Service Bulletin

Bulletin No.: 17-NA-181

Subject: Reduced Throttle, Engine Stalling, No Crank/Start, ABS Light On, Malfunction Indicator Lamp (MIL) Illuminated - DTCs P0106, P0107, P0122, P018C, P0222, P0532, P0561, P0562, P057C, P057E, P0641, P0651, P0697, P06A3, P06D2, P103B, P1682, P16A7 and/or P2128 Set

| Brand: | Model: | Model Year: | | VIN: | | Engine: | Transmission: |
|-----------|----------------|-------------|------|------|----|------------|---------------|
| Chevrolet | Malibu (VIN Z) | 2016 | 2016 | | | 1.5L (LFV) | |

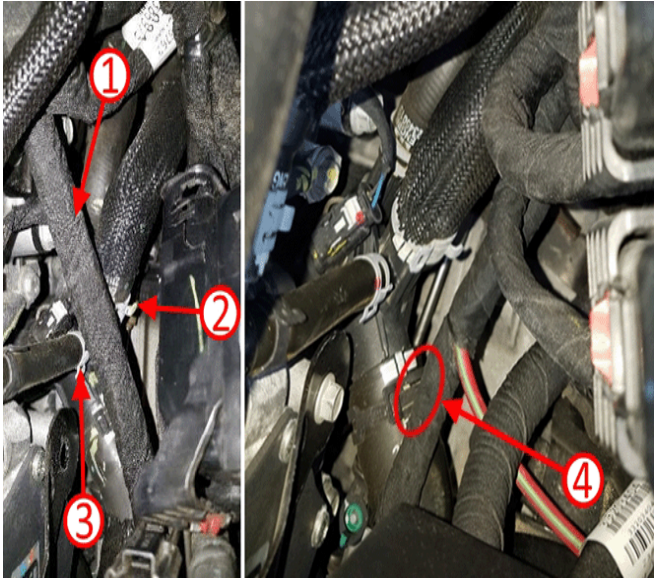
| Cause |  <p>4810882</p> <p>Note: This is a multi-wire bundled harness and, depending on which wire is damaged, can set a variety of DTCs.</p> <p>This condition may be caused by the engine harness (1) chaffing between the ECM and rear of engine at one or more of the following locations:</p> <ul style="list-style-type: none"> • Heater inlet hose clamp (2) • Engine coolant air bleed hose clamp (3) • Upper radiator inlet coolant hose clamp (4) |

| Correction | If any of the above conditions have been validated, inspection of the engine wiring harness must be done and repositioning of the coolant hose clamp. |

1. Inspect the engine wiring harness for contact at the upper coolant hose clamp.
 - If the wiring harness shows no signs of damage, refer to SI for further diagnostics.
 - If the wiring harness shows signs of chaffing, proceed with procedure.
2. Repair the wiring harness. Refer to *Wire to Wire Repair* in SI.
3. Wrap the engine wiring harness with Polyester Electrical/Anti-Abrasive Tape (PET) or equivalent anti-abrasion tape.
4. Reposition the coolant hose clamps so that it cannot contact the engine harness.
